Southern Nuclear Operating Company  
Vogtle Electric Generating Plant Units 3 and 4  
Revision 1 to Request for License Amendment:  
Use of AWS D1.1-2000 Criteria for Structural Welds (LAR-15-009R1)

**Revised Request for License Amendment Regarding**  
**Use of AWS D1.1-2000 Criteria for Structural Welds**  
**(LAR-15-009R1)**

**Revised Proposed Changes to Licensing Basis Documents**  
**(LAR-15-009R1)**

Figure 1. Fillet Weld Loading in Plane of Weld

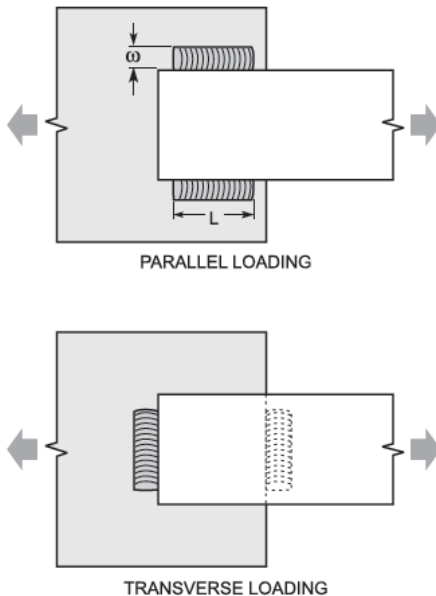
These changes are supported by industry tests that provide the justification for criteria that consider the load directionality. The testing and analysis is reported in an AISC Journal Article, “*Proposed Working Stresses for Fillet Welds in Building Construction*,” by T. R. Higgins and F.R. Preece. The referenced Higgins and Preece paper, describes tests on fillet welds loaded both parallel to and transverse to the axis of the weld in the plane of the weld, as illustrated in Figure 1. The Higgins and Preece paper provides a factor of safety summary related to a working stress of  $0.30F_{EXX}$ . The summary of test results demonstrates that the failure of the weld loaded transverse to the axis of the weld is approximately four times  $0.30F_{EXX}$ .

While the testing performed by Higgins and Preece was for weld groups loaded in the plane of the weld group elements, testing by Gomez et al. (Gomez, I., Kanvinde, A., Kwan, Y.K. and Grondin, G., "*Strength and Ductility of Welded Joints Subjected to Out-of-Plane Bending*," Final Report to AISC, University of California, Davis, and University of Alberta, July 2008) confirms that the strength increase defined in AWS D1.1-2000 Section 2.14.4 does not have to be restricted to loads in-plane with the axis of the weld group. Fillet welds loaded out-of-the-plane of the weld group were studied using cruciform-shaped configurations as illustrated in Figure 2. A purpose of the study was to determine if the effect of loading parallel to the root notch or transverse to the root notch was of significance. Results from the Gomez study of twenty-four cruciform tests indicate that the strength of fillet welds is not affected significantly by the presence of the root notch.

Figure 3. Circular Fillet Weld Group

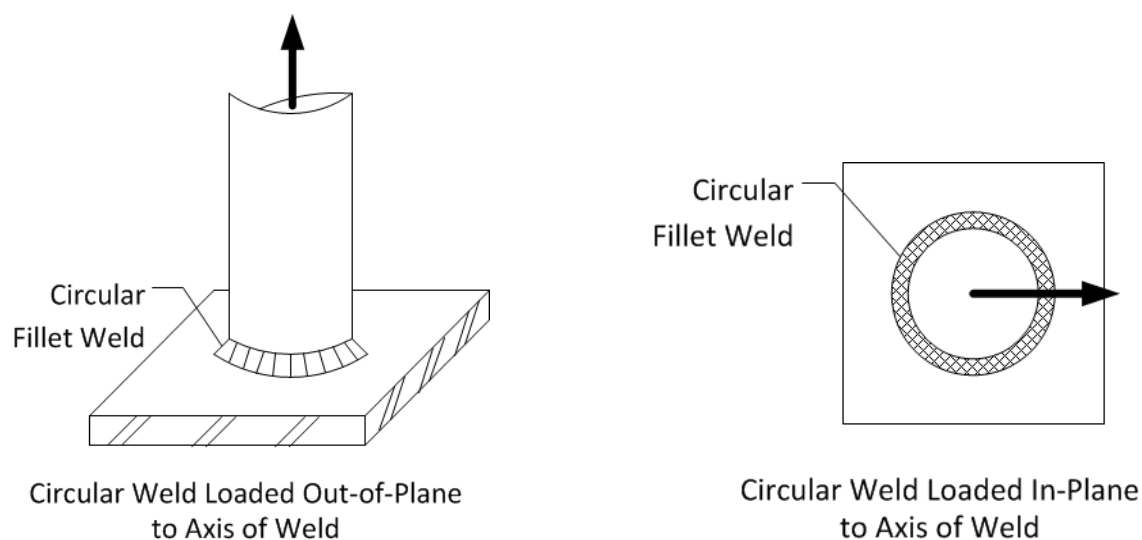
Circular fillet weld groups (e.g., fillet welds to anchor reinforcing bars, fillet welds to round rods, fillet welds to round tubes) are illustrated in Figure 3. A circular-shaped weld group or other curved line weld group, loaded out-of-plane to the axis of the weld has an equivalent loading

condition, because there is no difference in the behavior of the failure plane through the weld between a circular-shaped weld group and a rectangular-shaped weld group. The use of directionality for circular welds and curved line welds is limited to loading out-of-plane to the axis of the weld. For circular welds loaded in-plane to the axis of the weld, the angle of loading measured from the weld longitudinal axis is constantly varying. Due to this complexity, application of AWS D1.1-2000 Section 2.14.4 is excluded for circular welds loaded in-plane to the axis of the weld. The limitation on the use of directionality to out of plane load for circular weld groups is included in the licensing basis changes in UFSAR Subsections 3.8.3.2 and 3.8.4.2.

- *Provisions in Sections 2.14.4 and 2.14.5 of AWS D1.1-2000 may be used for the application of directionality to increase allowable weld stress for fillet welds identified in AISC N690, Section Q1.5.3 and Table Q1.5.3. The application of directionality may be used for in-plane and out-of-plane loading for linear weld groups, including lines and rectangular configurations. For circular weld groups, directionality is limited to out-of-plane loading.*
- *Provisions in Section 2.3.4.1 of AWS D1.1-2000 may be used to size complete joint penetration groove welds for tubular members.*
- *Provisions for matching weld metal identified in AWS D1.1-2000 Section 3.3 and Table 3.1, may be used for ASTM A992 steel and supplement the information in AISC N690 Section Q1.4.4.1\**

- *Provisions in Sections 2.14.4 and 2.14.5 of AWS D1.1-2000 may be used for the application of directionality to increase allowable weld stress for fillet welds identified in AISC N690, Section Q1.5.3 and Table Q1.5.3. The application of directionality may be used for in-plane and out-of-plane loading for linear weld groups, including lines and rectangular configurations. For circular weld groups, directionality is limited to out-of-plane loading.*
- *Provisions in Section 2.3.4.1 of AWS D1.1-2000 may be used to size complete joint penetration groove welds for tubular members.*
- *Provisions for matching weld metal identified in AWS D1.1-2000 Section 3.3 and Table 3.1, may be used for ASTM A992 steel and supplement the information in AISC N690 Section Q1.4.4.1\**
